ADDENDUM NUMBER 04

DATE: February 02, 2024

PROJECT: Cass District Library Edwardsburg, MI

PROJECT NUMBER: 22-1836

SHEET TITLE:

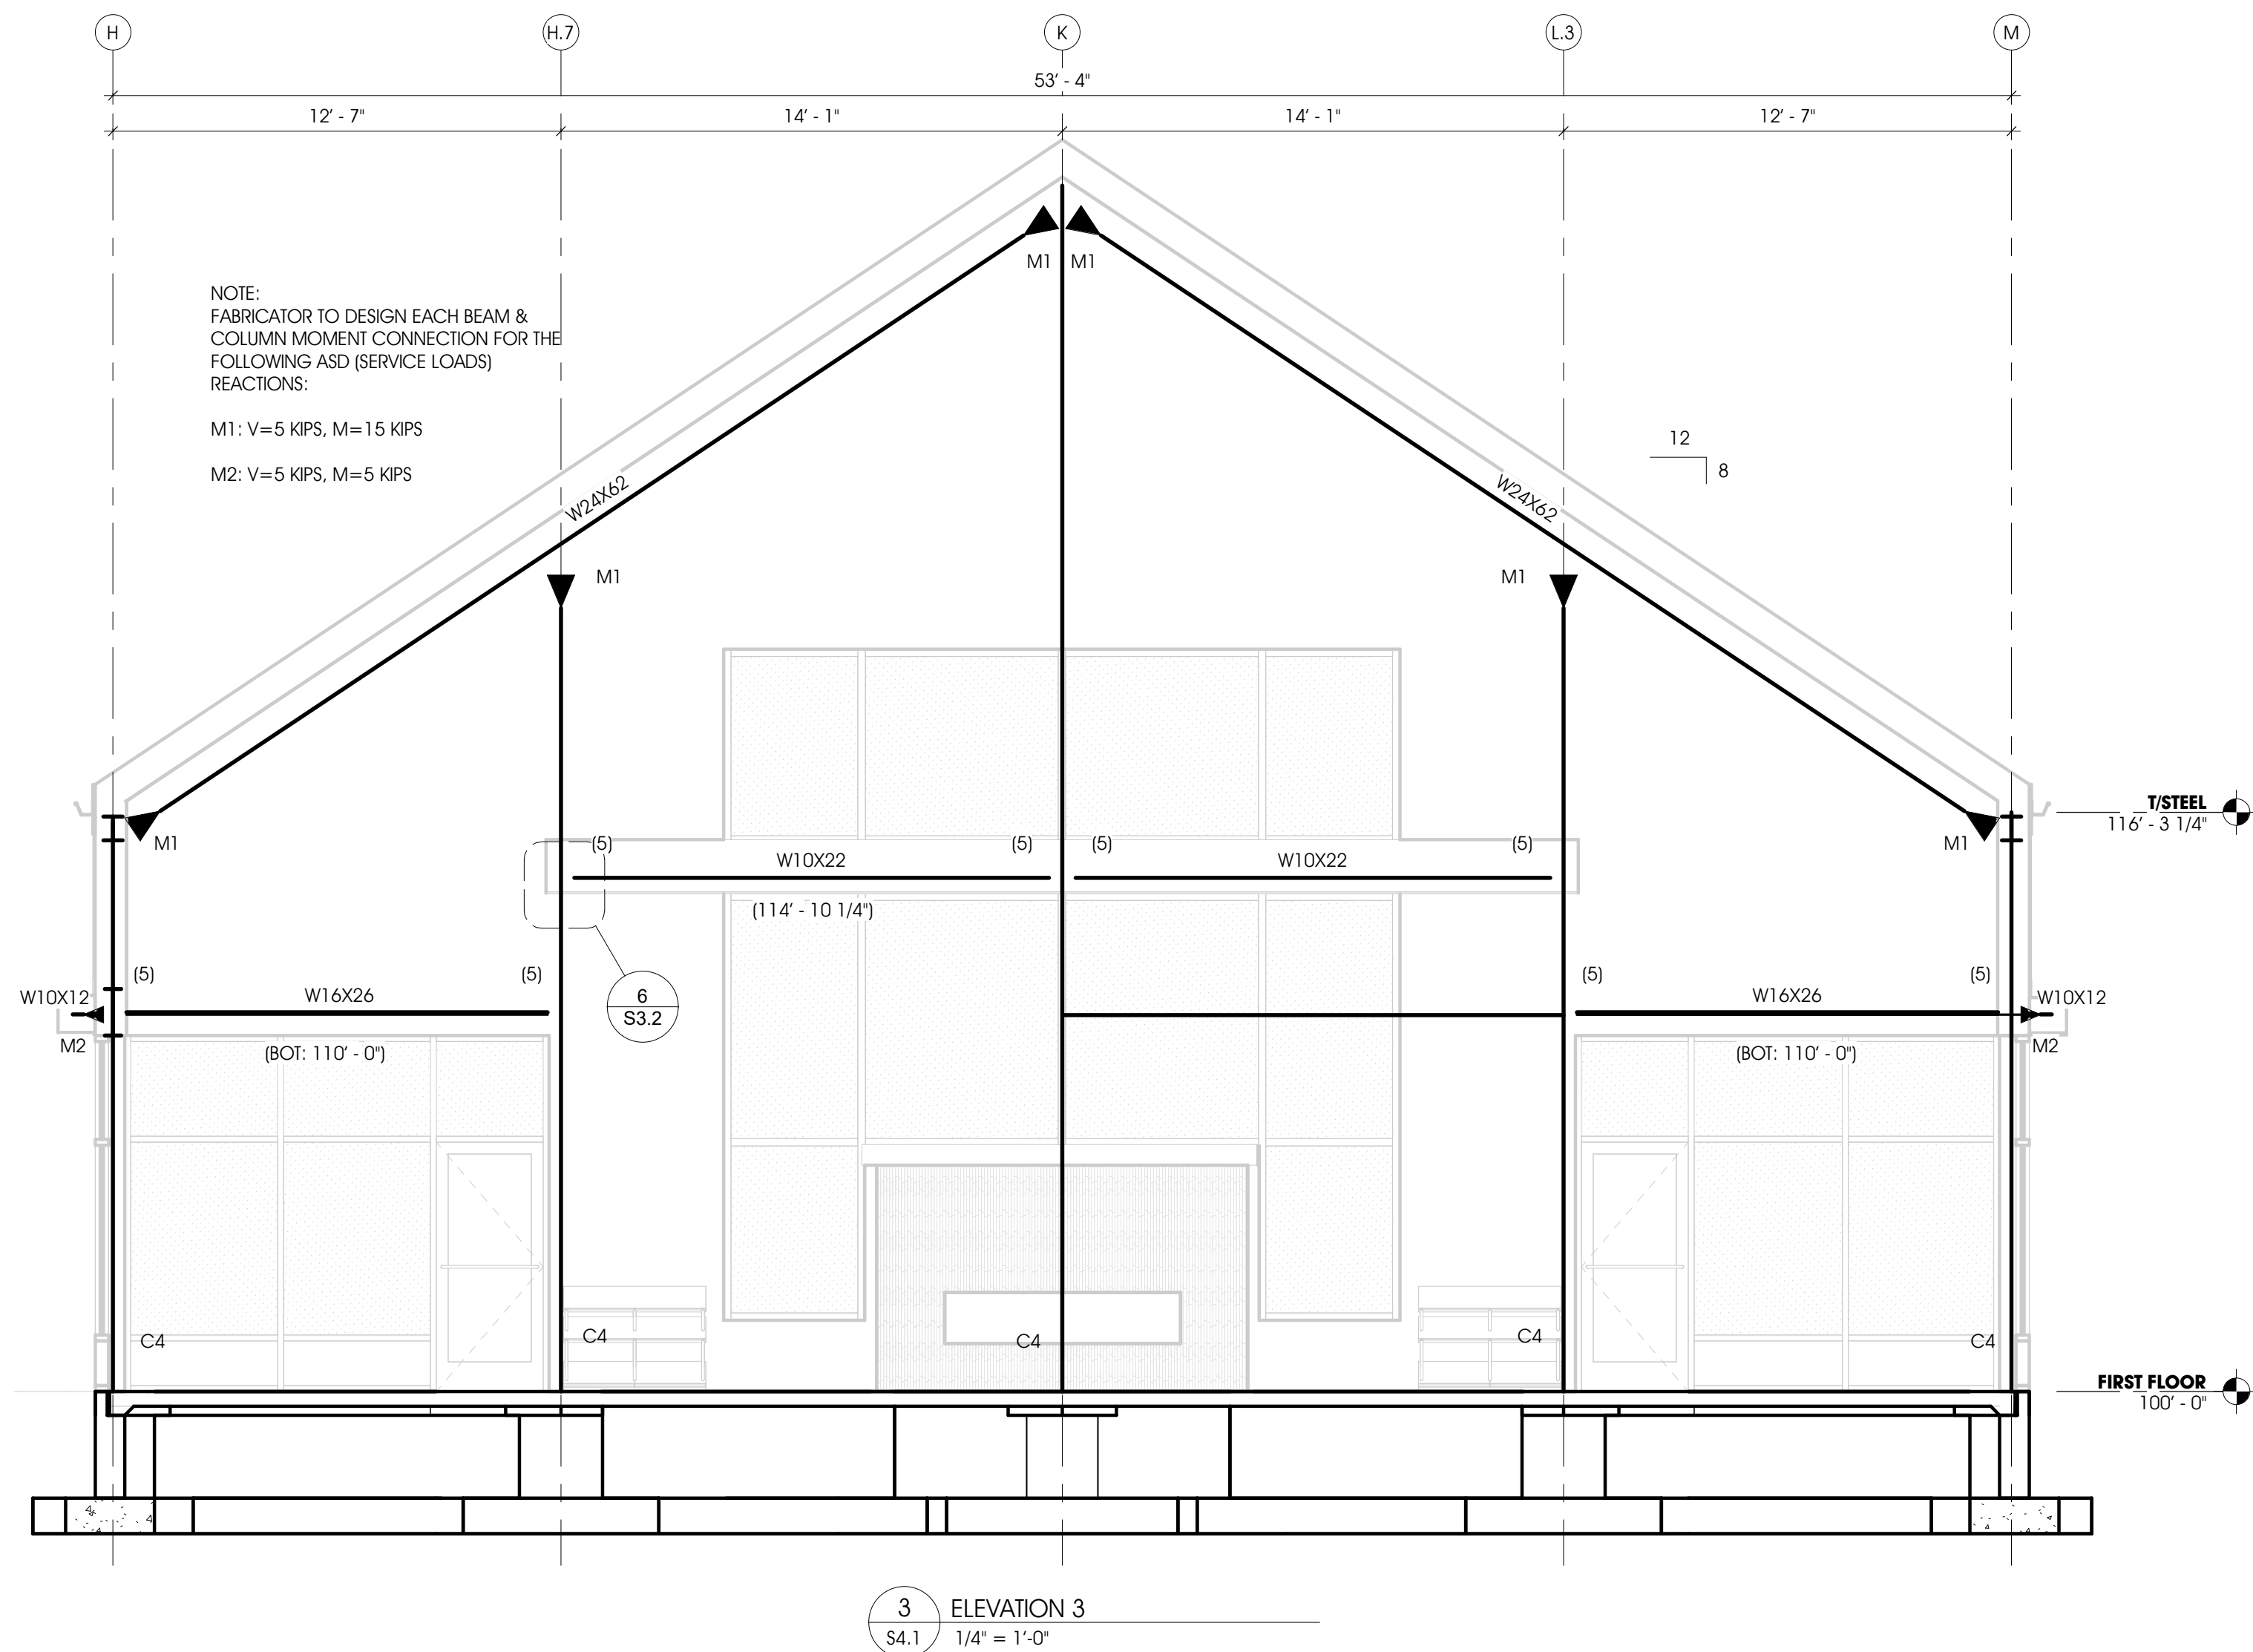
12. **CLARIFY** Bracing on detail callouts.

11 BRACED BAY DETAIL  
S4.2 3/8" = 1'-0"

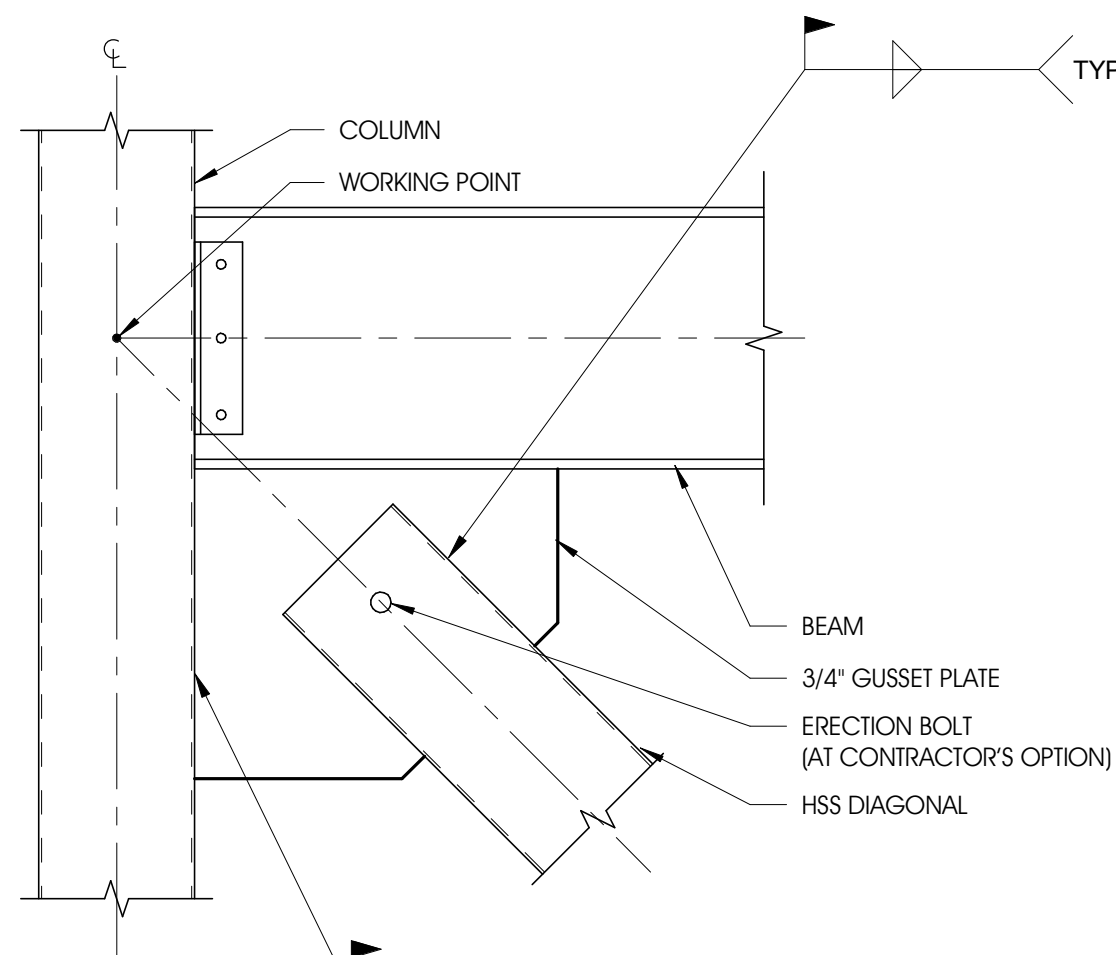
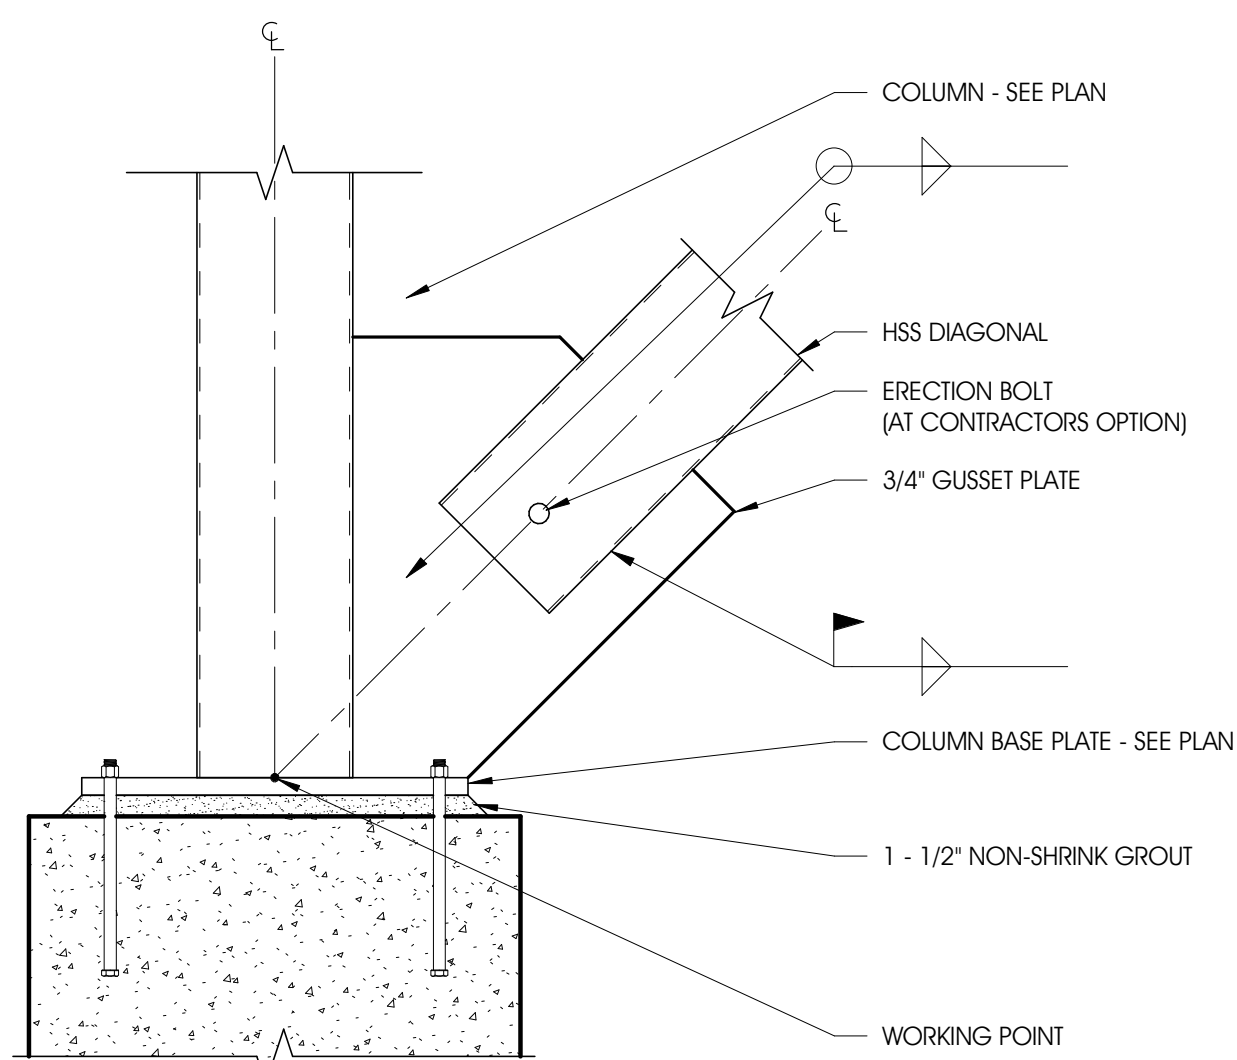
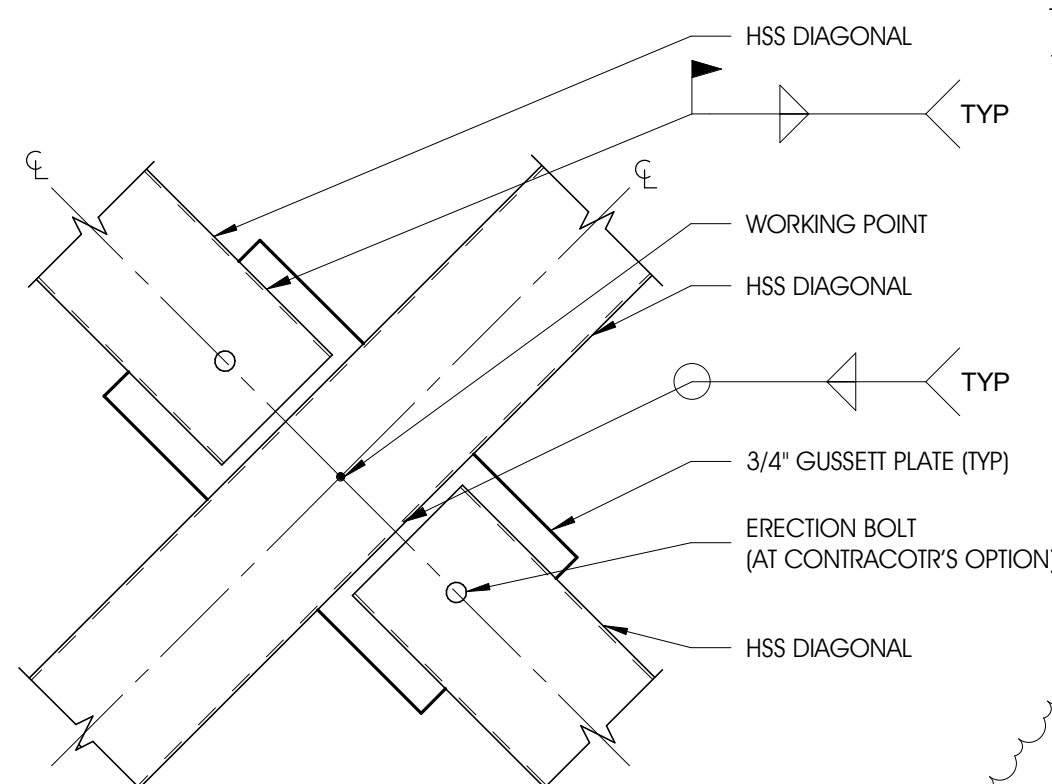
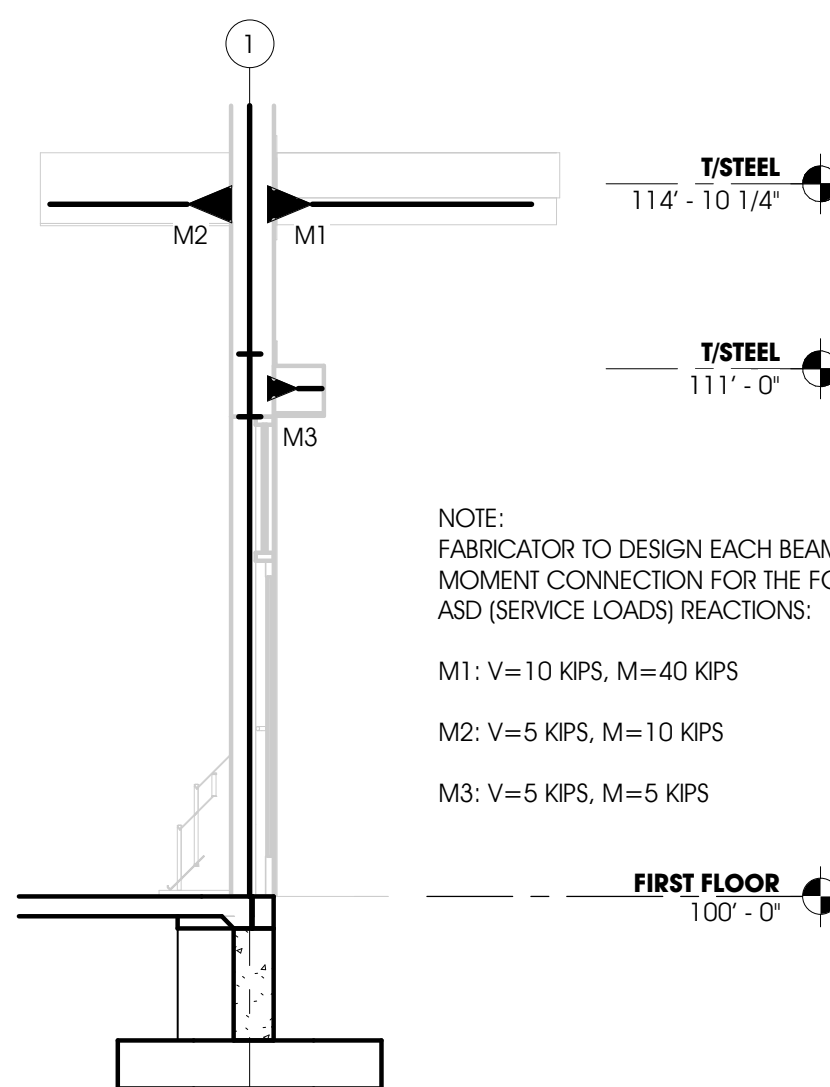
13. **CLARIFY** Bracing detail callouts and bracing details.
